Lot _____ Blk _____ Subdivision _____ Water Tap Date _____ Depth _____
 Address _____ Sewer Tap Date _____ Depth _____
 General Contractor _____ Sub-Contractor _____
 Inspected By _____

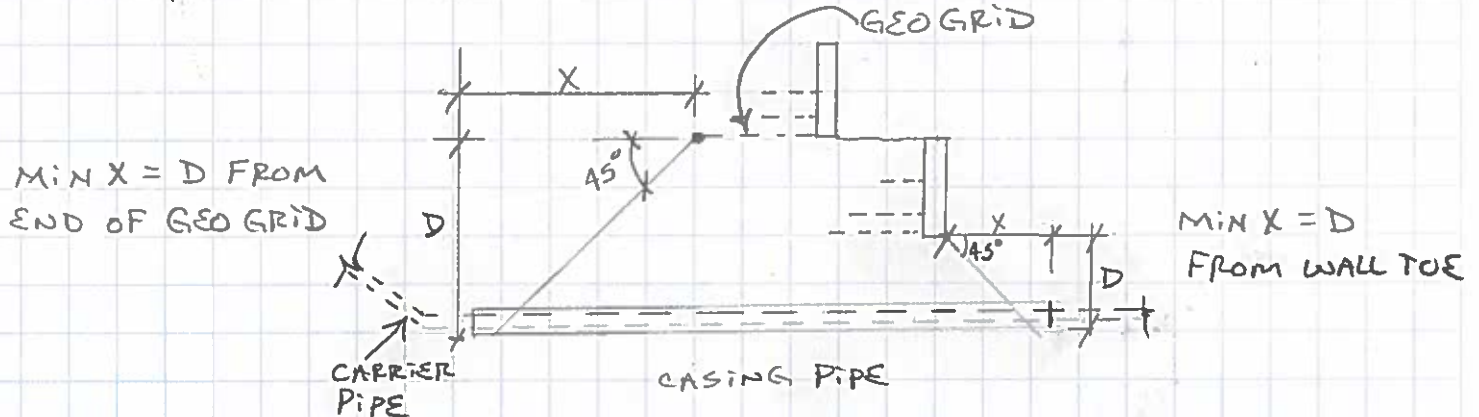
1) ABANDON EX. 6" WATER RUNNING SOUTH EAST THROUGH NORTHERN END OF SITE, REMOVE EX. FIRE HYDRANT NEAR STA 4+14, 15'R

2) CASING PIPE NEEDS TO EXTEND FAR ENOUGH IN EACH DIRECTION TO CLEAR GEOFABRICS & RETAINING WALLS:

3) RE ROUTE STORM CONC. PIPE TO AVOID EXCESSIVE CONGESTION

4) MOVE EXIST. PRV VAULT TO THE WEST

5) CONNECT WELL 5 DISCHARGE TO 12" NPW PVC LINE

6) RE-ROUT EXIST & PROP. SS

7) MOVE STORM SEWER INLET @ SOUTH END OF RED BRIDGE PT.

8) REROUTE EXIST SS EAST OF SITE TO MH IN SHORE DITCH HEIGHTS
